SERVICE ADVISORY 25-467

Aspen Trail Dinette Back

Models Included: 2025 Aspen Trail Travel Trailers

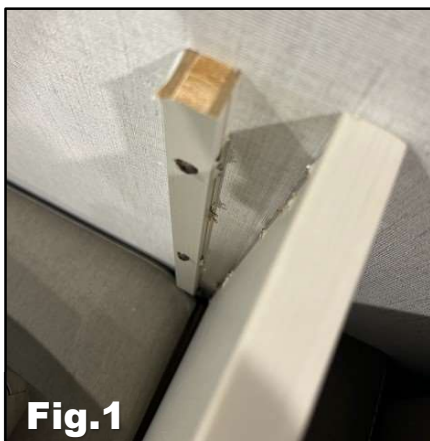
It has been determined there is inadequate support for the dinette back. The following procedure describes how to identify and secure the dinette backs.

Remove cleat from dinette back using putty knife or scraper tool to gently pry, use screw gun remove screws and discard cleat. **Figure 1** shows cleat installed.

The remedy: Remove cleat from dinette back, install six L-Brackets with 5/8 “wood screws to seat back.
